23 April 2026

RE: RESPONSE TO COUNCIL FURTHER ADVICE - MATERIAL CHANGE OF USE FOR A CHILDCARE CENTRE UPON LAND LOCATED AT 49 NOTTINGHAM ROAD, CALAMVALE QLD 4116 - COUNCIL FILE REFERENCE A006895884.

Figure 1: Proposed revised Ground Floor Plan indicating extent of deep planting adjacent to the western side boundary to ensure Trees #1 to #11 are protected and retained upon redevelopment.

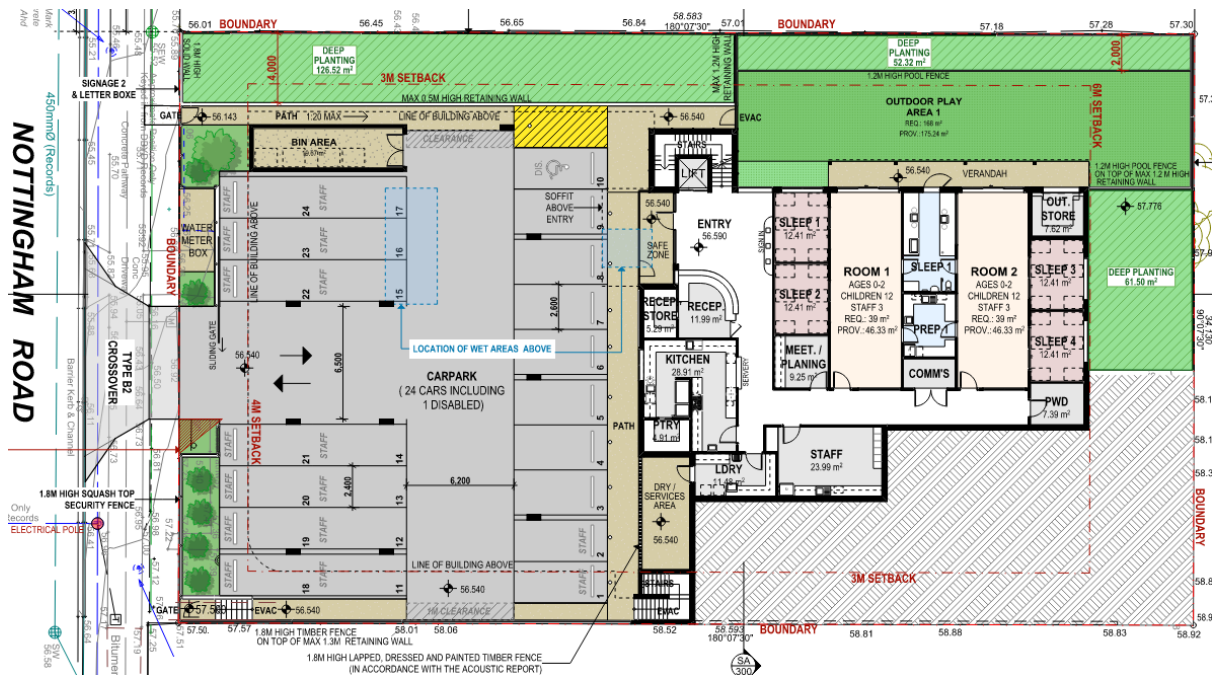
- 1) *The Arboricultural Impact Assessment (AIA) includes “pending” recommendations for the retention of trees on the adjoining lot along the western side boundary. Insufficient information has been submitted to demonstrate these trees on adjoining lots are adequately protected and will be retained and protected. The extent of encroachment is not supported, and it is recommended that exploratory vacuum excavation be undertaken, as recommended in the AIA, to allow the Arborist to reach firm conclusions and recommendations. These recommendations are required to inform a revised proposal to ensure the existing trees on the adjoining lot are retained and protected.*

- a) *A revised AIA with recommendations to ensure the protection, health and long-term viability of Trees #1 to #11 located wholly or partly on adjoining lots and provide a copy of the revised AIA for assessment. Neighbouring consent would be required prior to carrying out exploratory vacuum excavation as recommended in the proposed AIA.*
- b) *Revised proposed Architectural and Landscape plans in accordance with the Arborist’s recommendations to ensure the healthy retention of Trees #1 to #11.*

As requested, and in direct response to the above item, please be advised that the architectural plans have been revised, significantly reducing the extent of cut / retaining as previously proposed along the western side boundary and ultimately ensuring the trees over the adjoining property, subject to the recommendations as detailed in the Revised Arboricultural Impact Assessment, can and will be retained and protected upon redevelopment.

- Relocated the driveway crossover to the central portion of the site and reconfigured the car parking arrangement and associated bin store location. This in turn allowed for the finished floor level (FFL) of the car parking area and ground floor level to be raised from 56.090m AHD to 56.540m AHD (i.e. approx. 500mm).

- The disabled carpark has been relocated to the west adjacent to the primary pedestrian entry path (now car bay 10).
- The previously proposed retaining wall along the western side boundary has been moved within the property to achieve a 4m clearance from the side boundary to the retaining wall at the front portion of the site.

- At the rear of the property, and due to the proposed level changes, Outdoor Play Area 1 has been rationalised to incorporate a batter up to the side boundary. Note no retaining is now proposed at this portion of the site.

- The extent of deep planting across the site has been reconfigured and rationalised, with the development now proposing a total deep planting area of 240m² (12% of the site area) across the site, generally concentrated adjacent to the western side boundary. This is a favourable outcome when considering the extent of existing landscaping over the adjoining property, which is inclusive of a number of existing mature shade trees. When combined, a substantial landscape buffer will be provided between the two properties.
